Bulletin #:	2006-003	Date:	06/07/06
Product:	☒ Compressor	☐ Generator	☐ Tools
Subject:	Exhaust flexible clamp replacement

Models	
7-26E	SN, see table below
7-31E	SN, see table below

Technical Service Bulletin

Figure 1 Old clamp

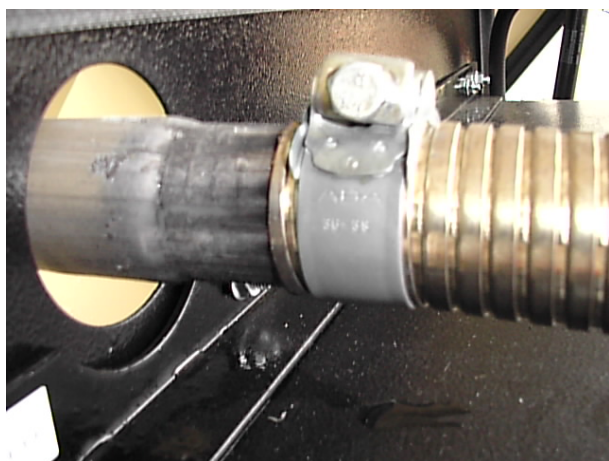
Some clamps used to tighten the exhaust flexible on the engine exhaust pipe and muffler were found to give insufficient clamping load. As a result the flexible can disengage.

To solve this problem a U-bolt clamp CPN 92898576 is now used. Refer to Figures 2 and 3 for the orientation of the clamps.

Make sure the flexible is equally engaged at least 30 mm on both sides and not fully extended to leave it some flexibility.
